FAIRMOUNT STREET/OGDEN STREET

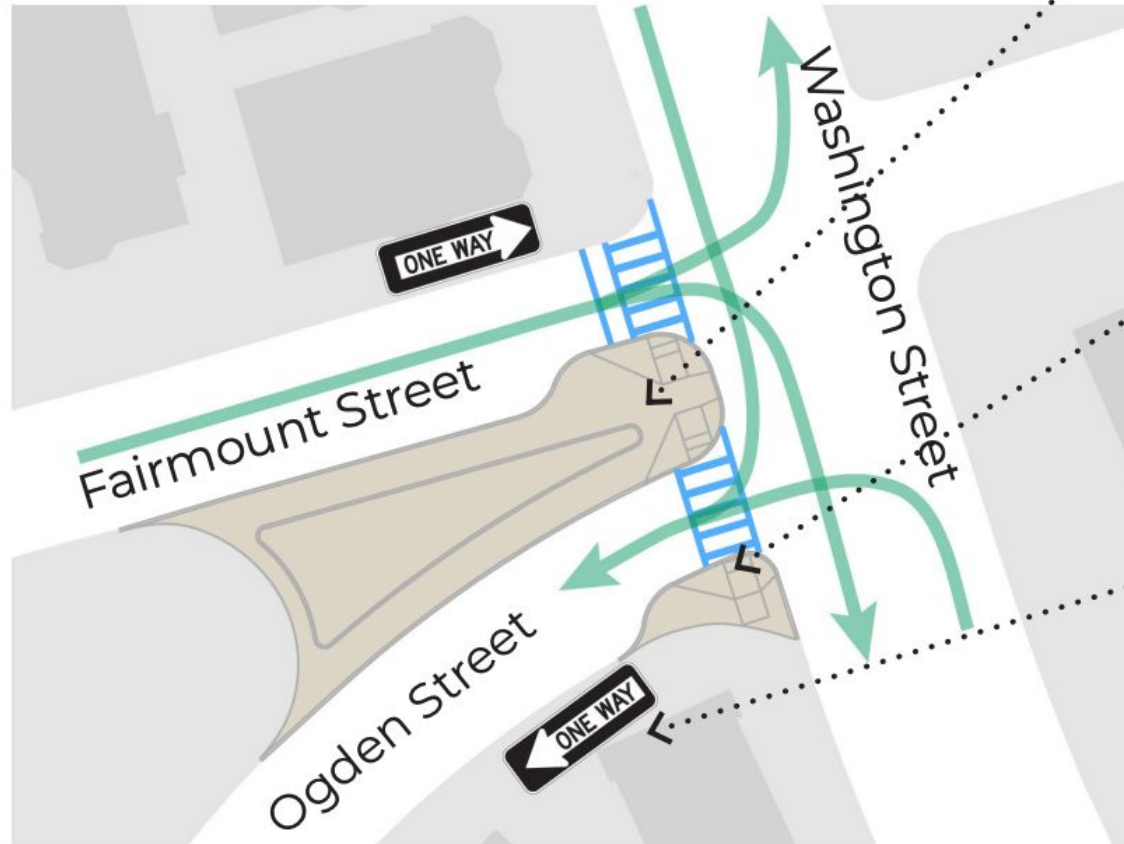
- Crosswalk is really long (~70 feet long!)
- Intersection is confusing and dangerous
- Ogden is too narrow for two-way travel
- Wide intersection encourages speeding

Center median and pedestrian island

shortens time in crosswalk and provides a “refuge” for people crossing

Curb extensions

will encourage slower driving and safer turns

One-way streets in/out

Convert Ogden to one-way toward Wilmington to simplify travel flow.
